Rockwell service letter

No. SL-AG-82

Service Letter No. SL-AG-82
5 February, 1976

TAIL WHEEL TRUNNION ASSEMBLY MODIFICATION

Figure 1.

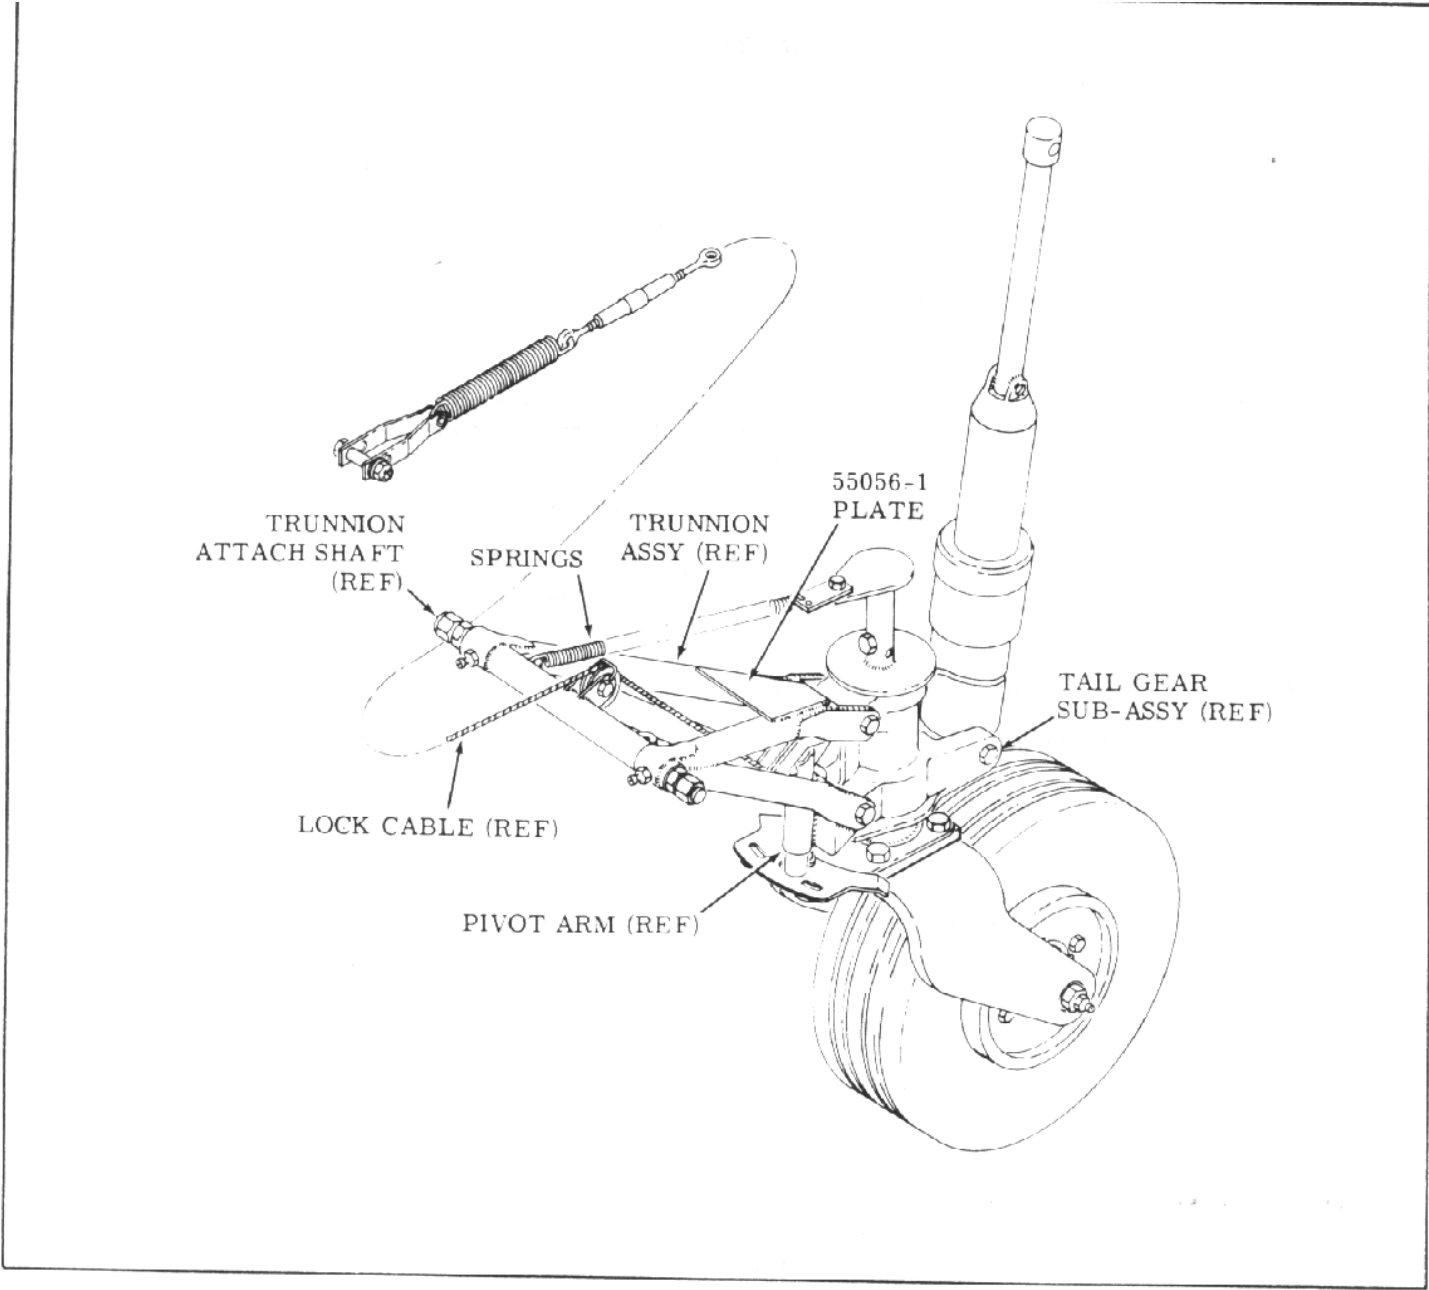
REASON FOR PUBLICATION: STRENGTHEN TRUNNION ASSEMBLY AND PREVENT POSSIBLE BREAKING OF WELDS IN FORK AREA FOR AIRCRAFT OPERATIONS FROM UNIMPROVED FIELDS,

1. Jack and secure tail of airplane.
2. Remove tail wheel trunnion assembly as follows:
 - a. Disconnect lock cable at pivot arm.
 - b. Disconnect springs from trunnion assembly.
 - c. Remove bolts, nuts and washers that attach tail gear sub-assembly to trunnion assembly.
 - d. Remove nuts and washers from trunnion attach shaft.
 - e. Remove trunnion assembly by withdrawing trunnion attach shaft.
3. Weld 55056-1 plate on trunnion assembly (see Figure 1.).

Material is 4130 steel condition "N", S-0345.
